ADDENDUM NO. 4

**BREWSTER CENTRAL SCHOOL DISTRICT
BREWSTER HIGH SCHOOL
SECURITY VESTIBULE, SYNTHETIC FIELD AND RELATED WORK**

DATE: May 7, 2024

This Addendum consists of two (2) pages plus Sketches SK-10, SK-11, SK-12, specification section 32 1413 Brick Pavers, revised drawing BHS C401, C501, C601, C602, C707 & C708.

05-07-2024	BID ADDENDUM #4
DATE	ISSUED TO
SCALE:	AS NOTED
FILE NO.	DRAWING NO.
23505.01	SK-10

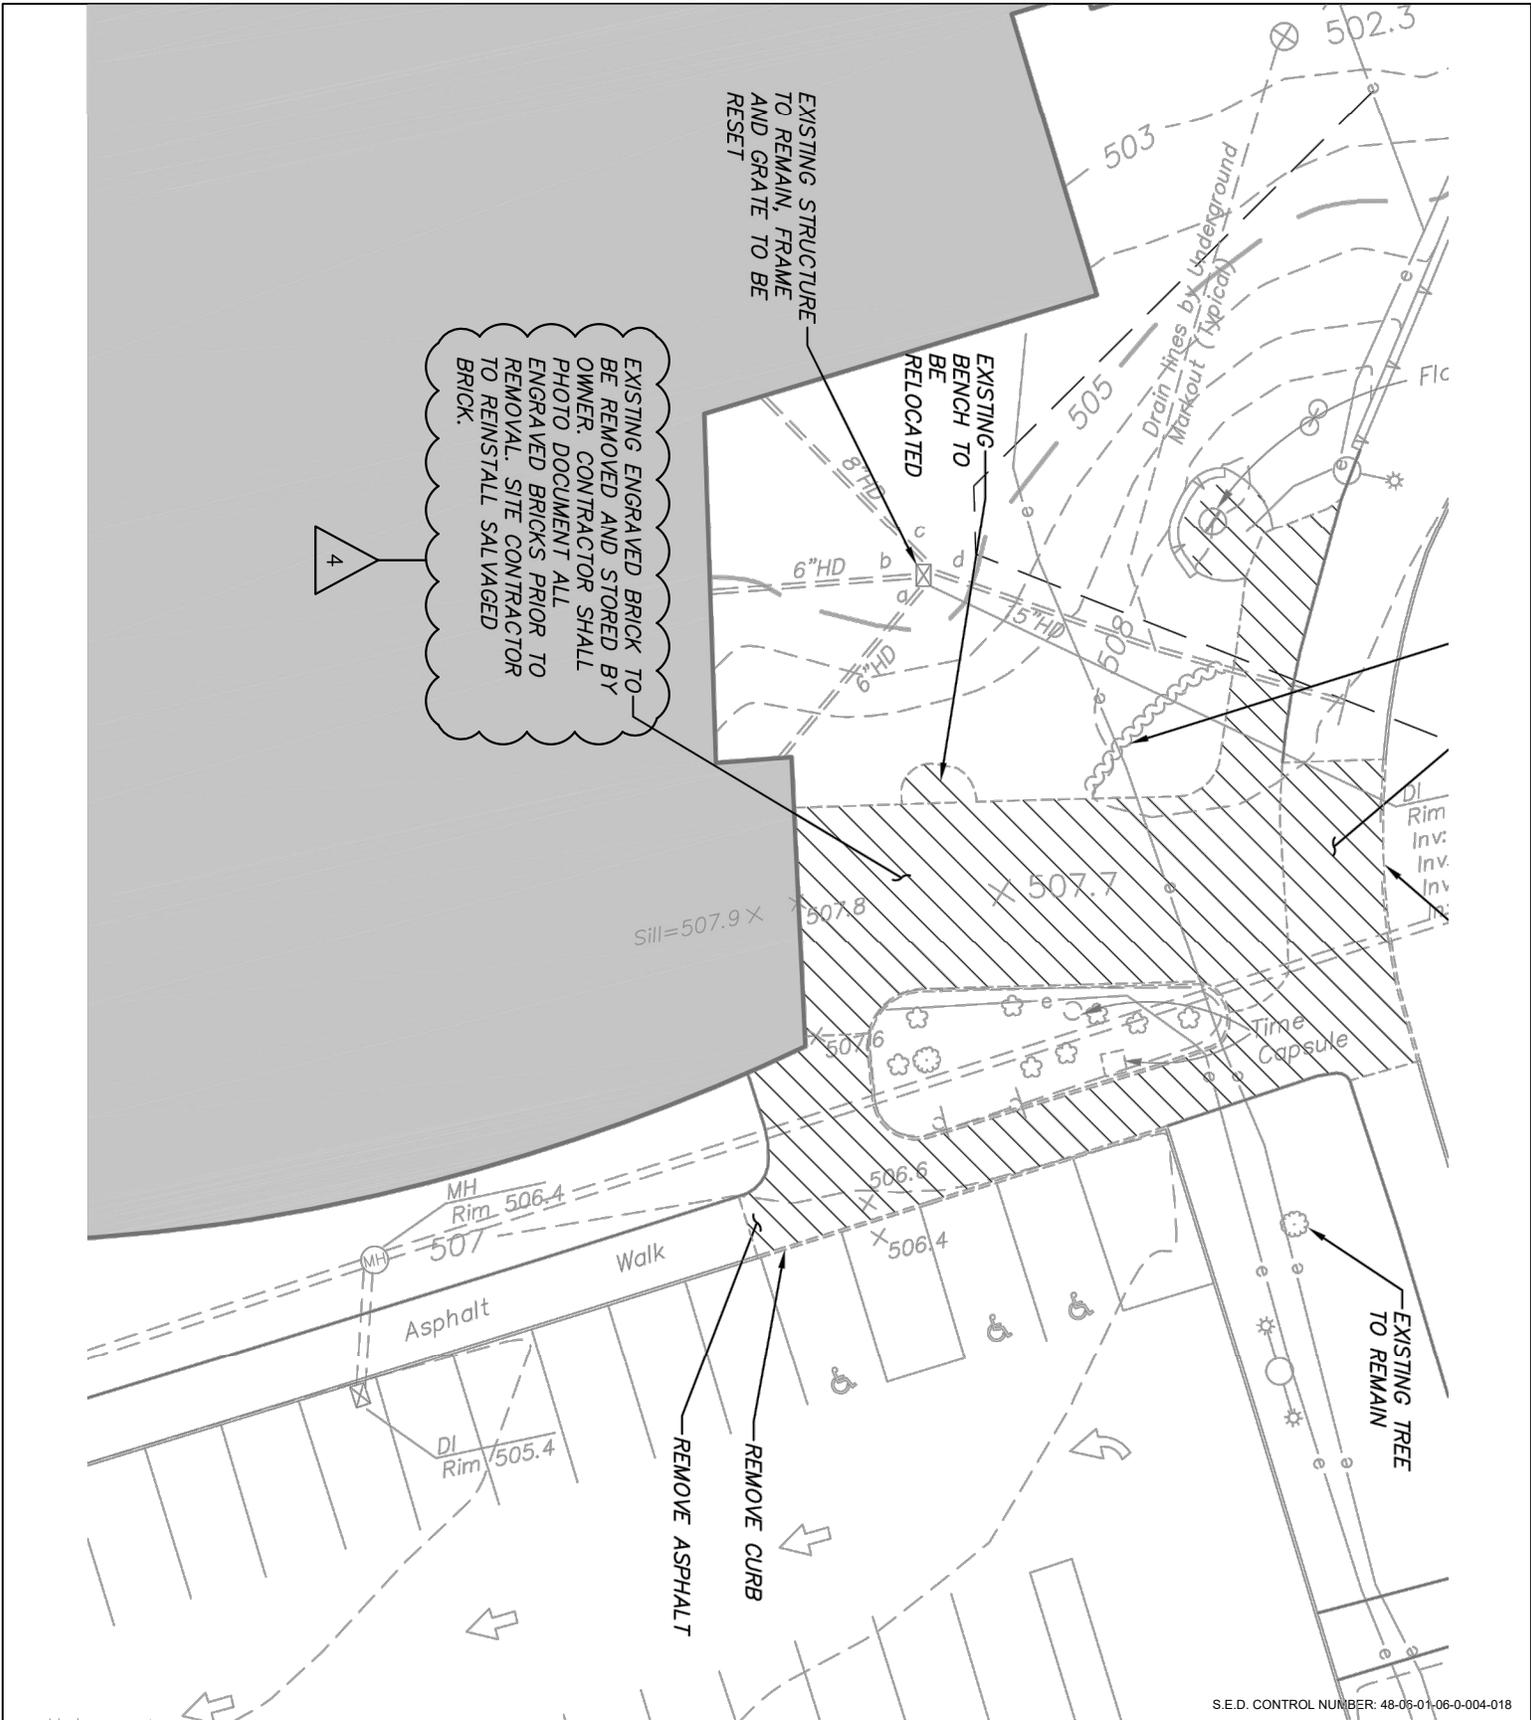
BHS C204 – EXISTING CONDITIONS AND REMOVALS PLAN

REVISE removal note as shown on Sketch SK-10 attached to this addendum.

05-07-2024	BID ADDENDUM #4
DATE	ISSUED TO
SCALE:	AS NOTED
FILE NO.	DRAWING NO.
23505.01	SK-11

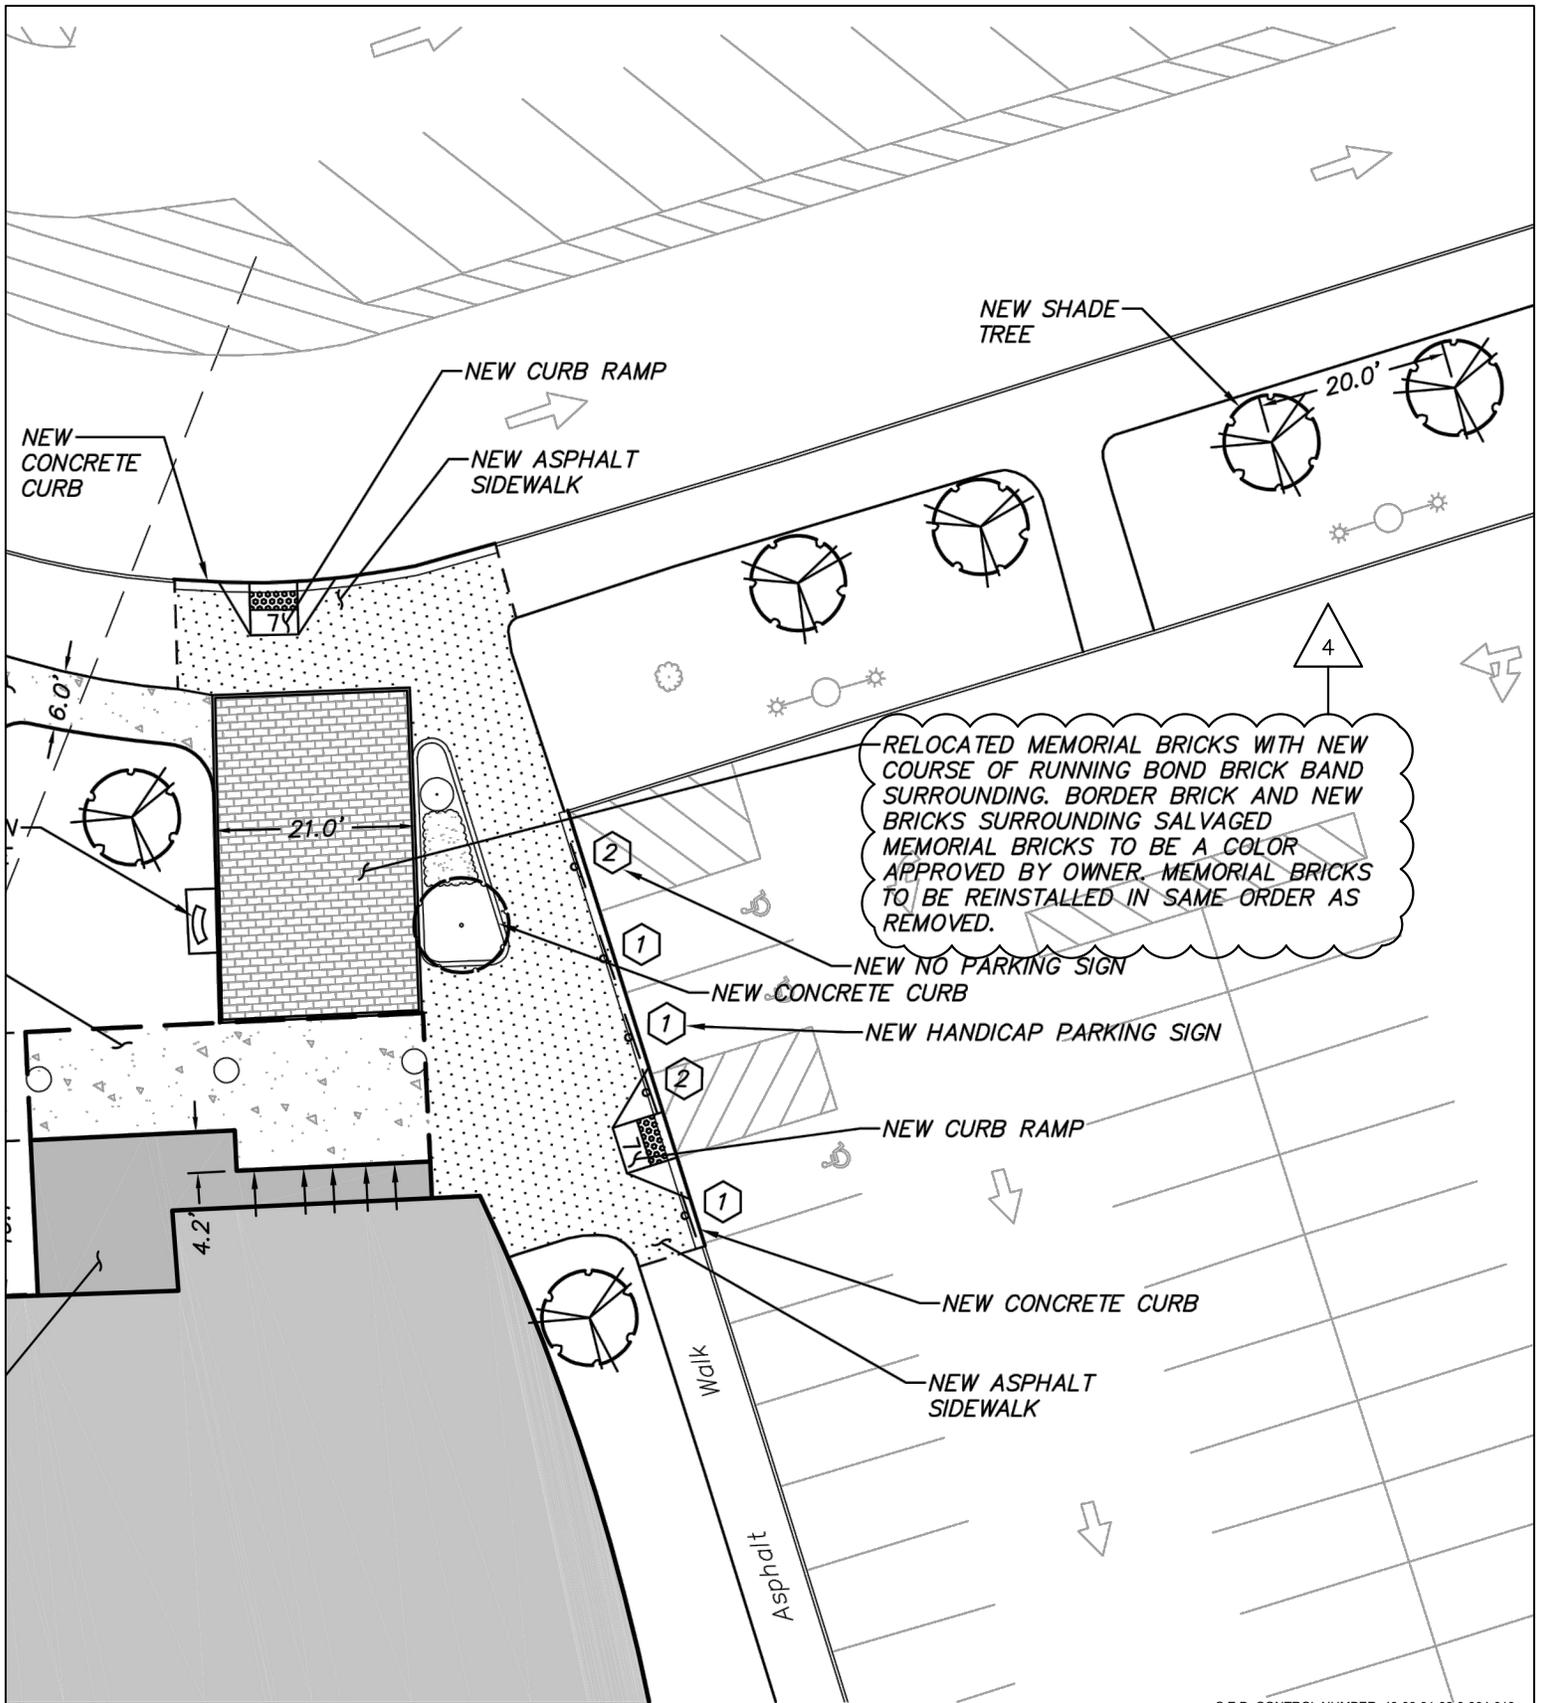
BHS C304 – LAYOUT AND LANDSCAPE PLAN

REVISE work scope note as shown on Sketch SK-11 attached to this addendum.

RELOCATED MEMORIAL BRICKS WITH NEW COURSE OF RUNNING BOND BRICK BAND SURROUNDING. BORDER BRICK AND NEW BRICKS SURROUNDING SALVAGED MEMORIAL BRICKS TO BE A COLOR APPROVED BY OWNER. MEMORIAL BRICKS TO BE REINSTALLED IN SAME ORDER AS REMOVED.

BRICK PAVERS DETAIL
 (N.T.S.)

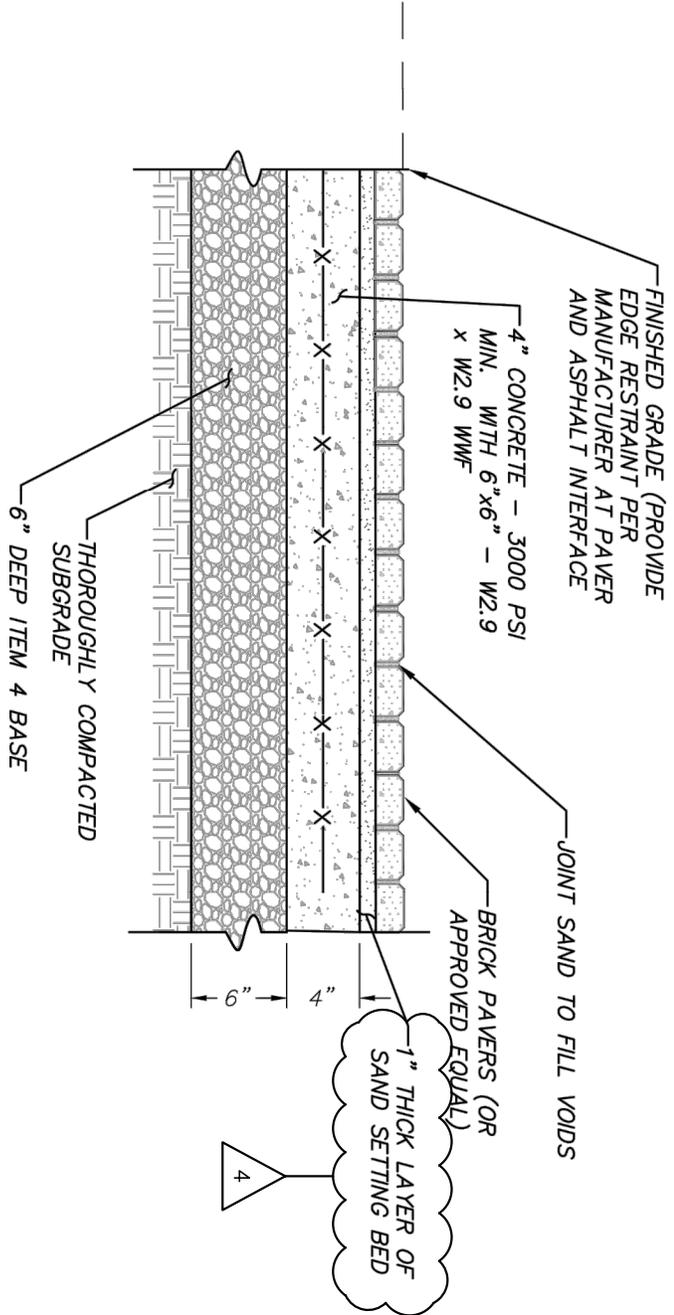
BHS C701 – DETAILS

REVISE Brick Pavers Detail as shown on Sketch SK-12 attached to this addendum.

NOTES:
 1. PAVERS TO BE SALVAGED MEMORIAL BRICKS SET IN RUNNING BOND PATTERN.

2. NEW BRICK SURROUND COLOR TO MATCH SALVAGED BRICKS.
 3. JOINT SAND COLOR TO BE COORDINATED WITH BRICK COLOR.

4. UTILIZE UNILOCK EDGE RESTRAINT BETWEEN THE BRICK BAND AND ASPHALT INTERFACE AS PER MANUFACTURER'S STANDARDS.

DRAWING TITLE:
 ATHLETIC FIELD, TRACK, AND PARKING AT
 BREWSTER HIGH SCHOOL
 GRADING AND UTILITIES PLAN

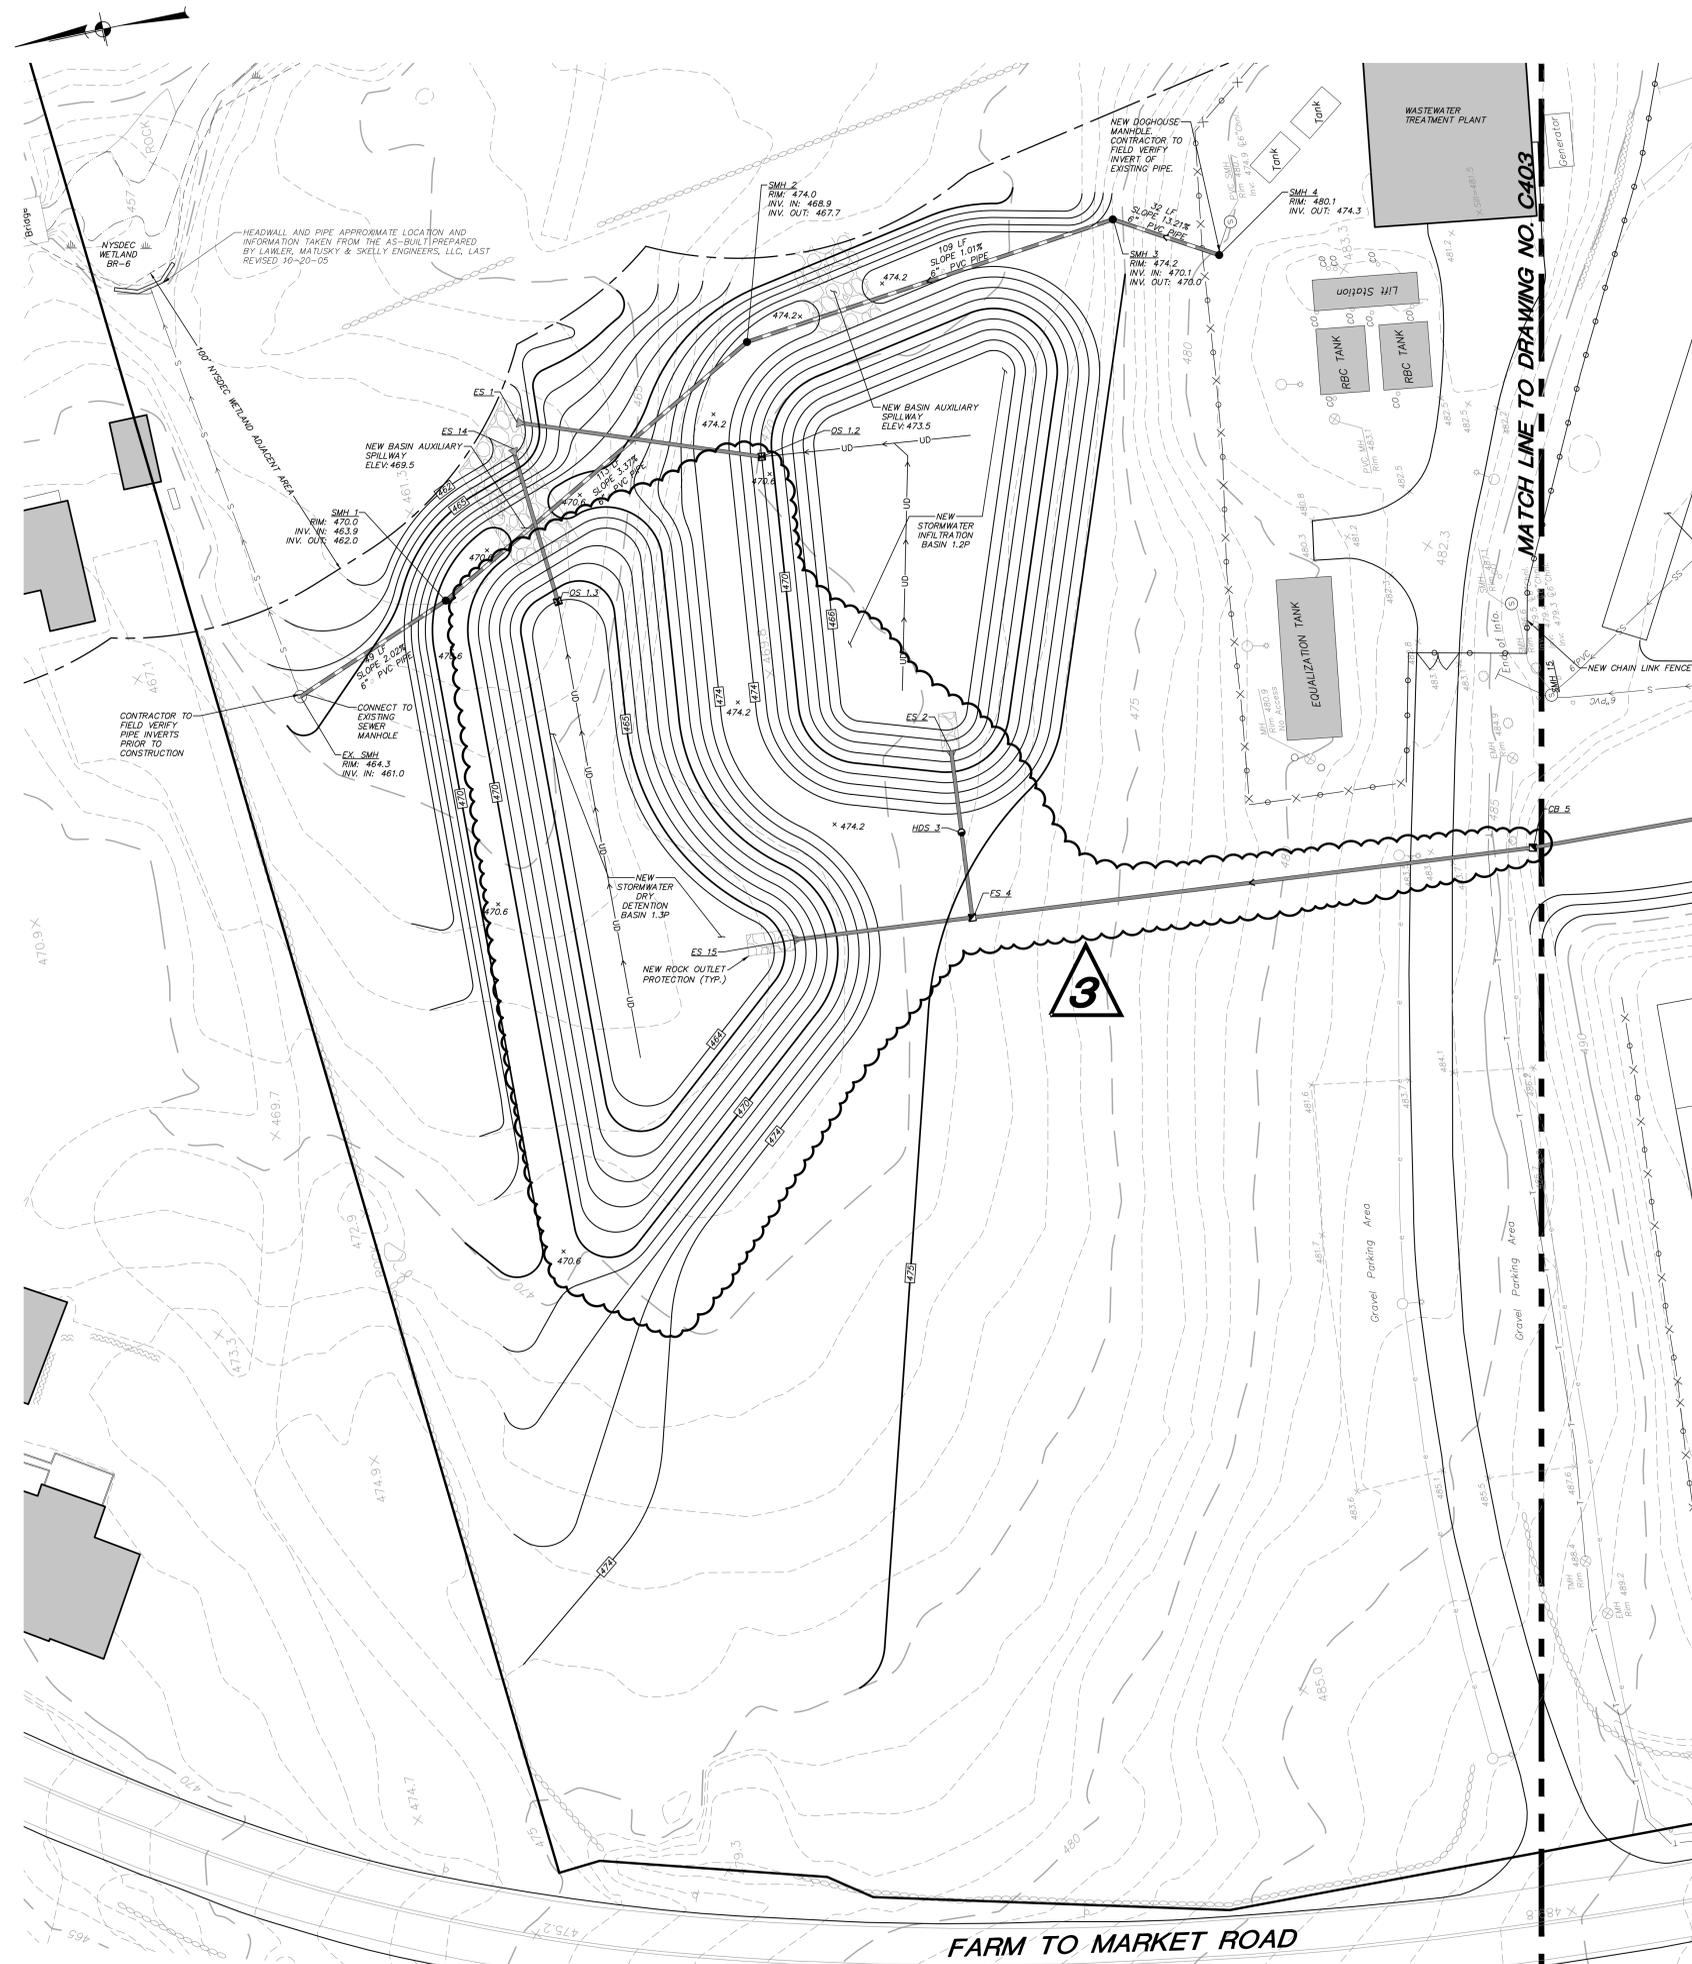
BHS C401 – GRADING AND UTILITIES PLAN

REVISE Drainage Table as shown on revised drawing attached to this addendum.

DRAINAGE TABLE					
Structure	RIM	INVERT ELEVATION	PIPE	LENGTH	SLOPE
ACO CB E	499.5	INV. OUT = 497.60 TO DI 11A	6" HDPE	39 L.F.	4.4%
ACO CB N	499.5	INV. OUT = 497.60 TO DMH 16	6" HDPE	54 L.F.	4.3%
ACO CB NE	499.5	INV. OUT = 497.60 TO DMH 9	6" HDPE	31 L.F.	4.5%
ACO CB NW	499.5	INV. OUT = 497.60 TO DMH 18	6" HDPE	36 L.F.	4.4%
ACO CB S	499.5	INV. IN = 497.60 FROM SC DRAIN INV. OUT = 497.60 TO DMH 22	4" HDPE 6" HDPE	14 L.F. 31 L.F.	2.2% 4.5%
ACO CB SE	499.5	INV. OUT = 497.60 TO DI 11B	6" HDPE	39 L.F.	4.4%
ACO CB SW	499.5	INV. OUT = 497.60 TO DMH 19	6" HDPE	36 L.F.	4.4%
ACO CB W (6")	499.5	INV. OUT = 497.60 TO DMH 18A	6" HDPE	36 L.F.	4.4%
CB 5	486.4	INV. IN = 475.20 FROM CB 6 INV. OUT = 475.20 TO FS 4	30" HDPE 30" HDPE	226 L.F. 160 L.F.	1.3% 2.1%
CB 6	490.8	INV. IN = 478.10 FROM DI 7 INV. OUT = 478.10 TO CB 5	30" HDPE	197 L.F.	1.1%
CB 8	493.4	INV. IN = 482.10 FROM F TO DI 11B INV. IN = 487.50 FROM DMH 9 INV. OUT = 481.10 TO DI 7	18" HDPE 30" HDPE 30" HDPE	45 L.F. 124 L.F. 88 L.F.	1.3% 1.5% 1.0%
